To: All Those Interested in the Renovation Plan for Playground 89 at P.S. 166

Parks has made a few revisions to its plan for the playground renovation following the meeting of the Community Board 7 Parks & Environment and Youth Education & Libraries committees on May 22. Pursuant to the committees' request, we met with the school principal and her staff to address her concerns. At our request, Paul Friedberg, the original playground architect, also attended the meeting. This latest plan has the support of both parties, and hopefully all others who have been interested in this project.

PLAYGROUND 89
MANHATTAN

Proposed Design

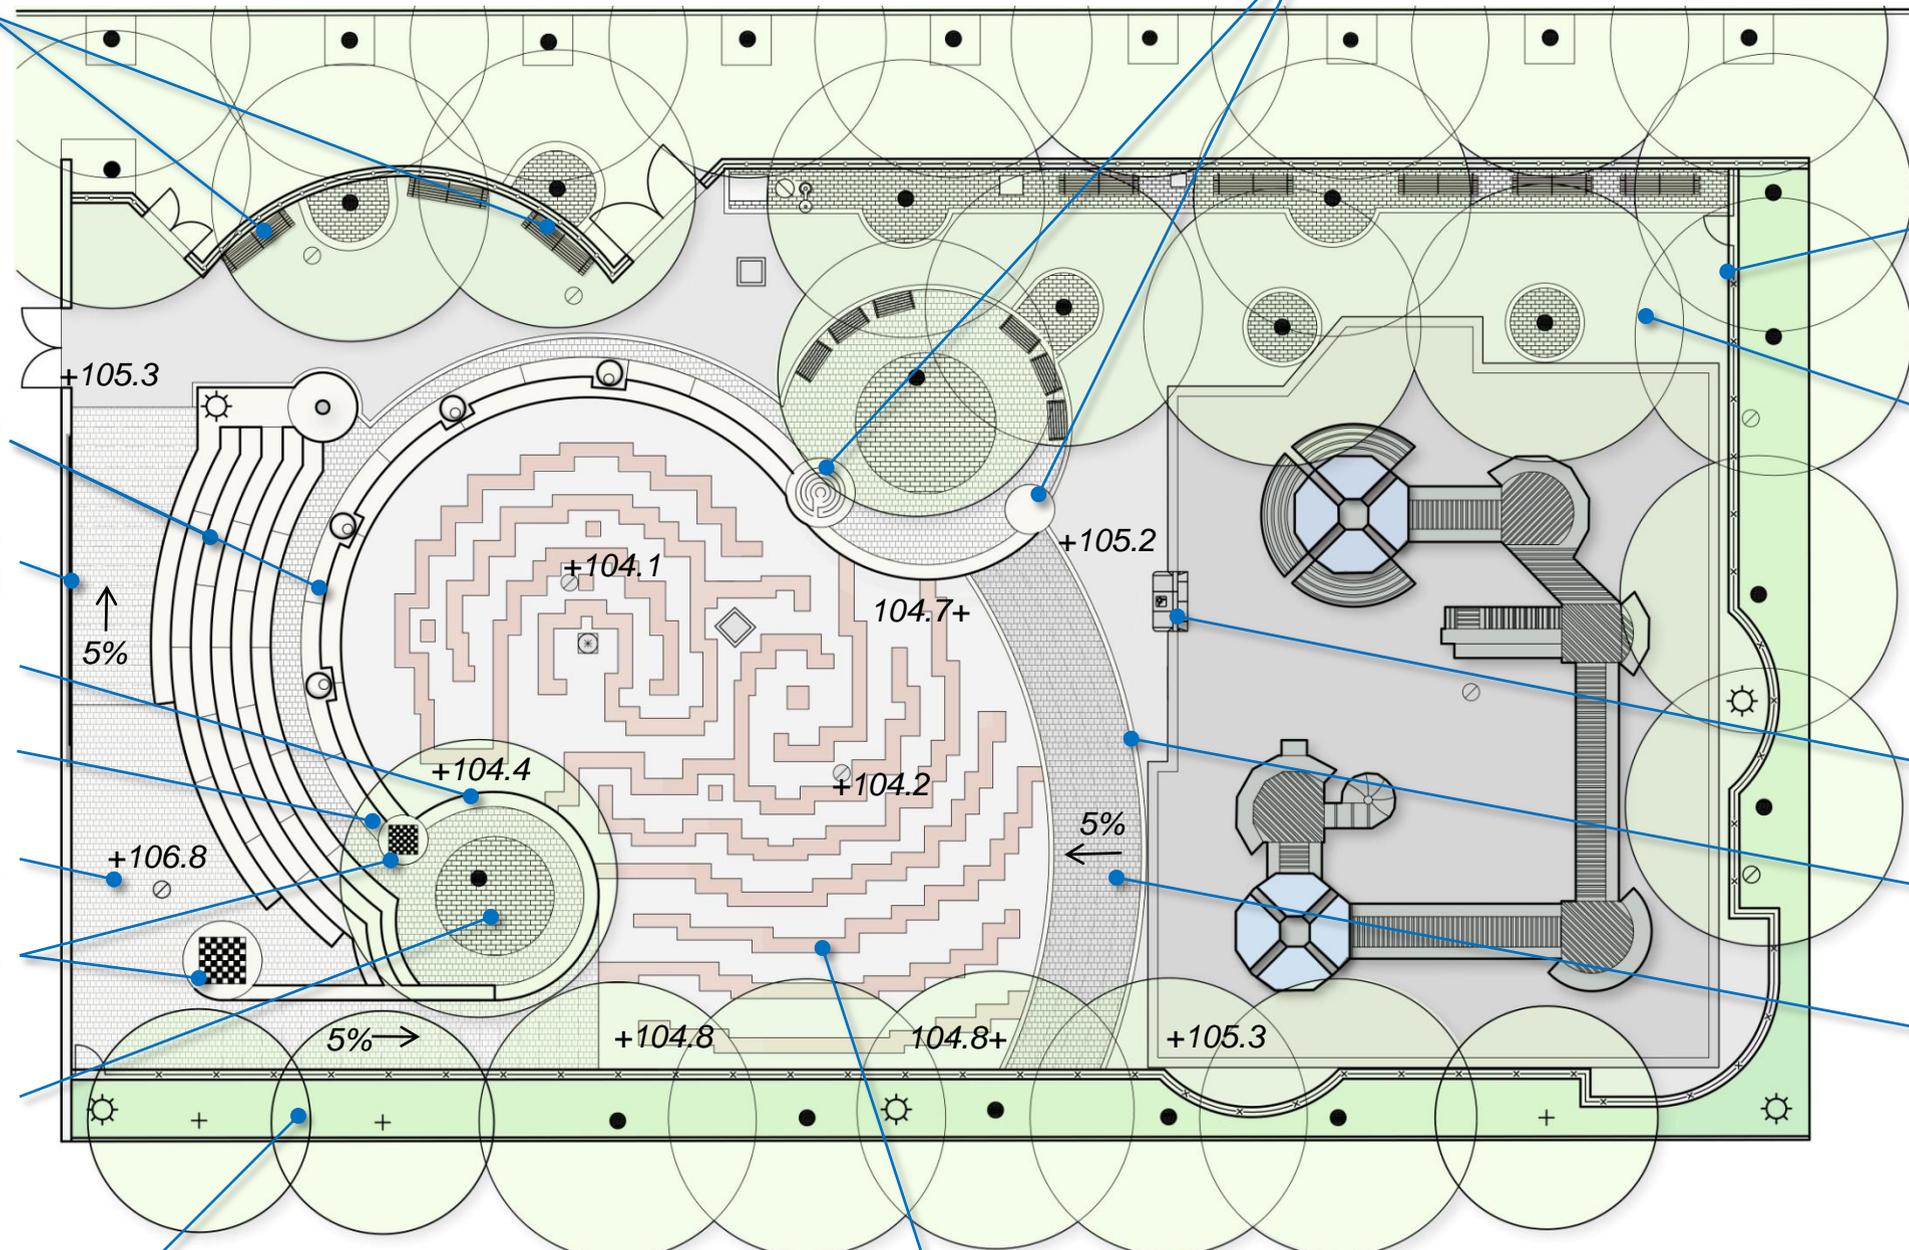
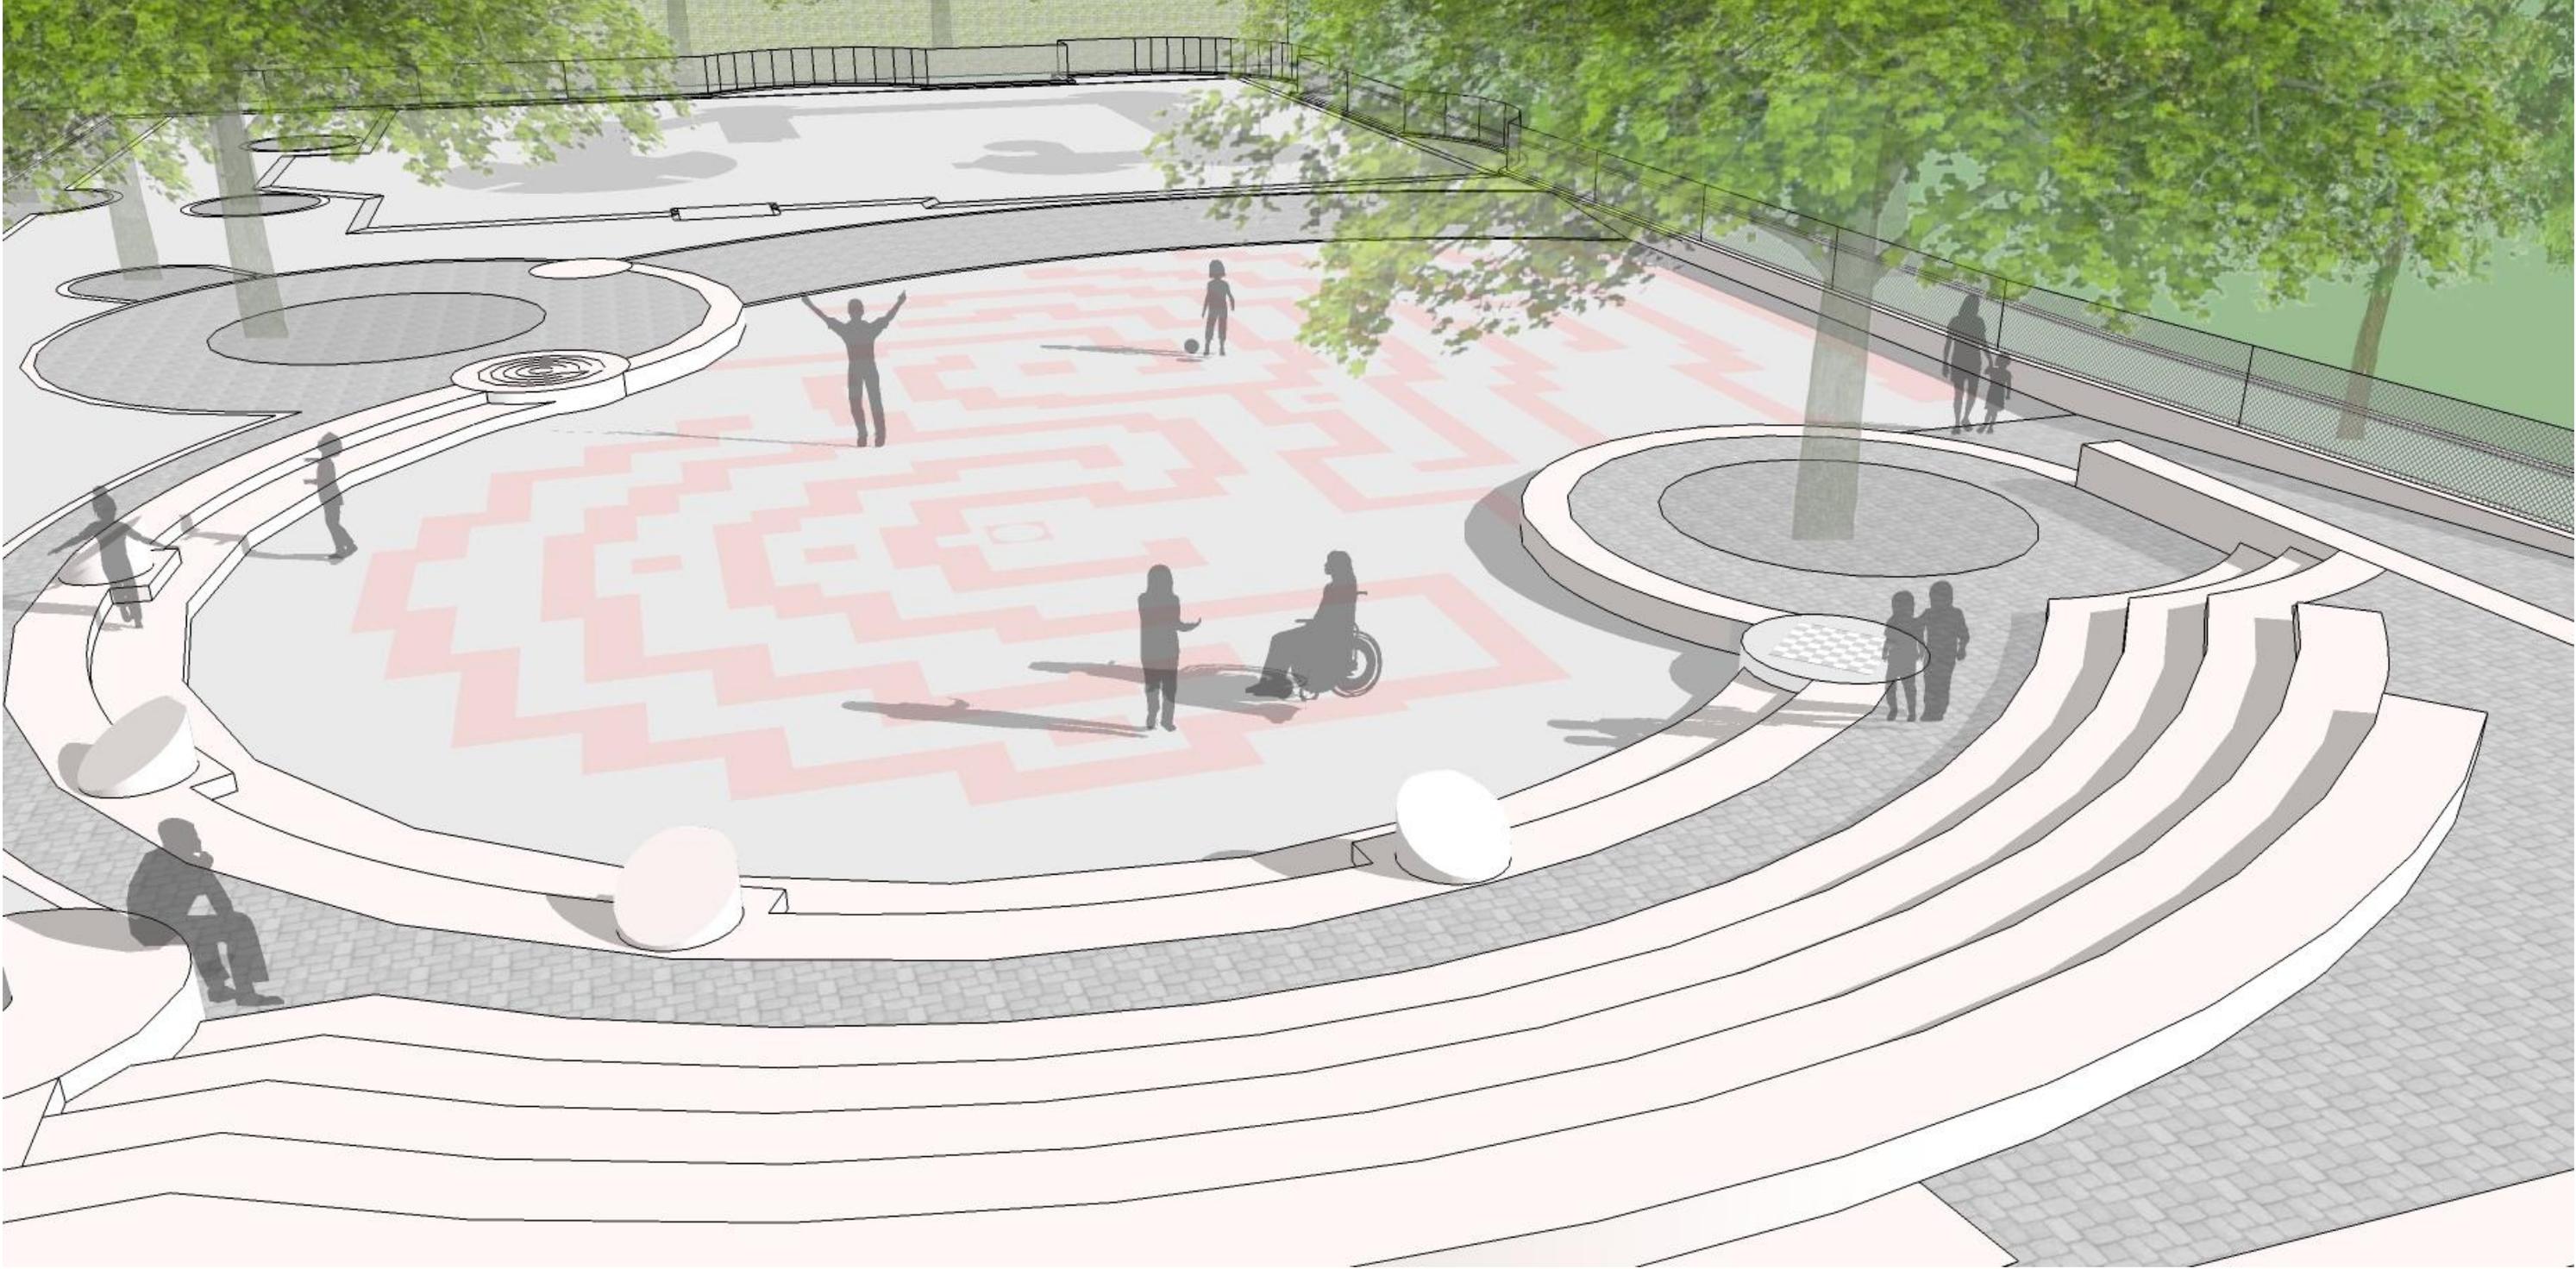
- An additional 1,140 square feet of flat area in the lower level, in comparison to the existing condition (existing plan 2240 SF; 5/22 plan 3040 SF; revised plan 3380 SF). The first step in the amphitheater has been incorporated into the flat area.
- A straightened/shorter sloped walkway/vehicle access in the southwest corner.
- Elimination of internal railings/fences.
- ADA-accessible granite block on a sloped area (instead of a ramp) between the play equipment and lower area.
- Relocation of proposed chess pod to the upper amphitheater area.
- An additional maze pod on northeast side of sunken area.
- Placement of the talk tubes play feature on the existing 4' fence near the play equipment.
- Addition of painted games including box ball and hopscotch ("potsy") on existing asphalt.

Existing & Proposed Sloped Transitions

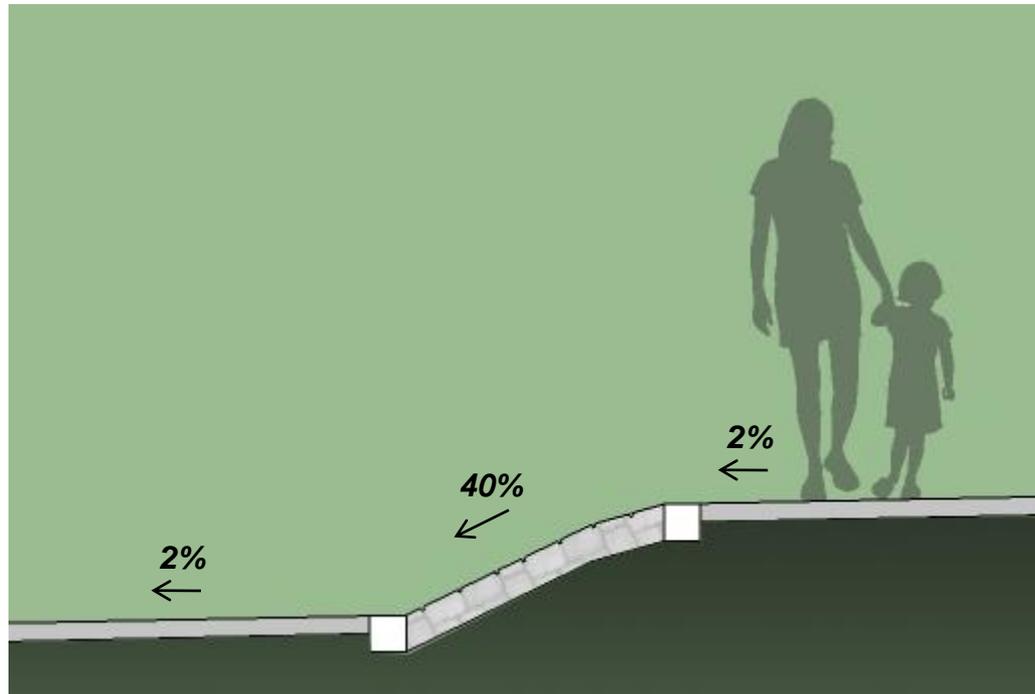
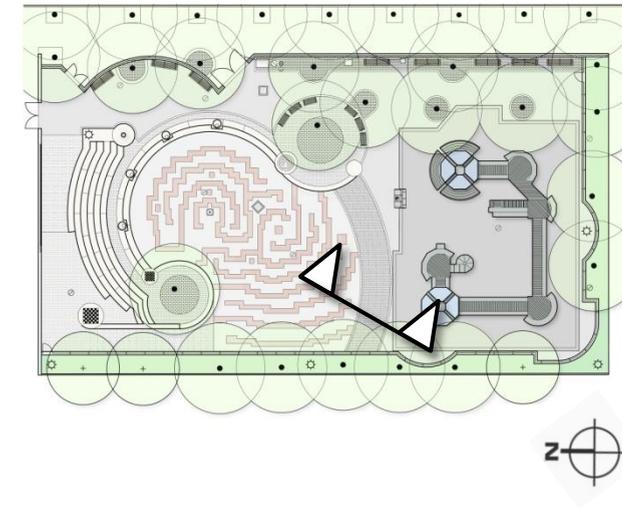
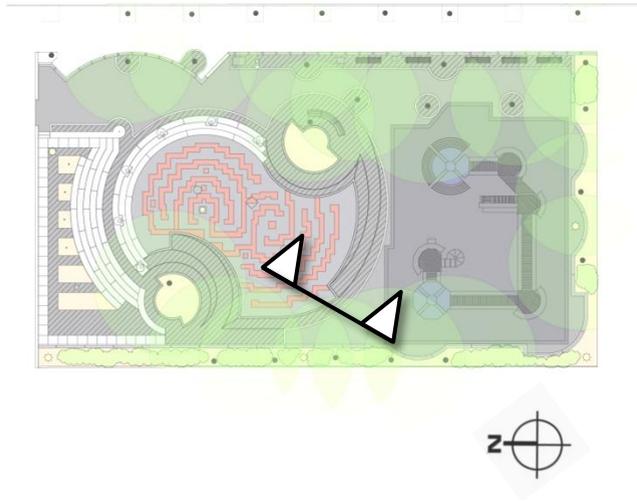
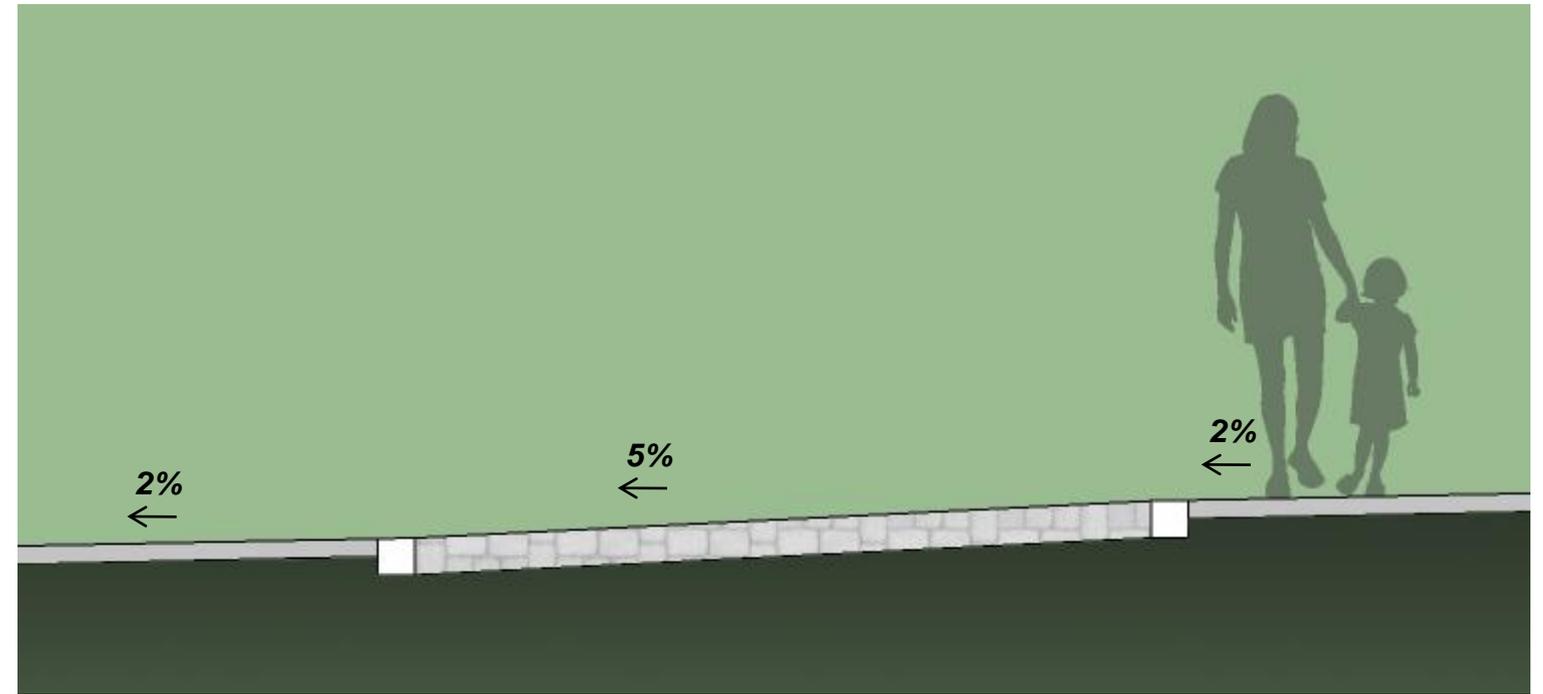
Existing 40% Uneven Granite Block Slope

Proposed 5% ADA Granite Block Slope
